ACCESS REPORT – DEVELOPMENT APPLICATION

**CLARENCE VALLEY CONSERVATORIUM
RENOVATIONS & ADDITIONS
8 VILLIERS STREET
GRAFTON NSW 2460**

Document Type: Access Report – Development Application
Report Number: IAC-1764

Ground Floor Plan

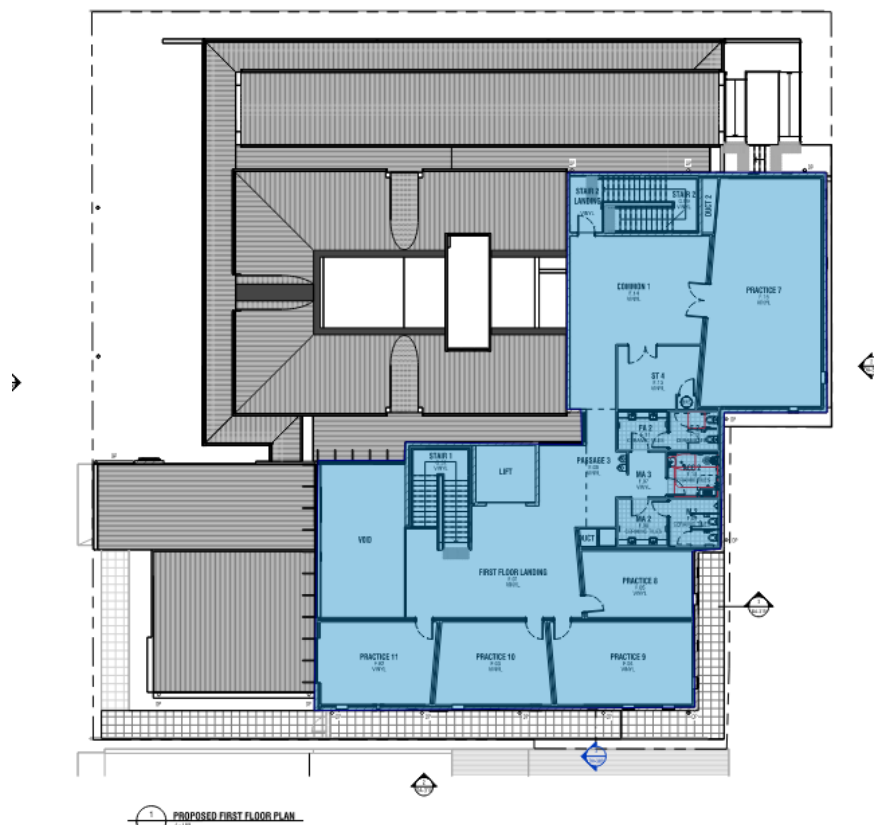
The markup of the plans following indicate the affected part of this project.
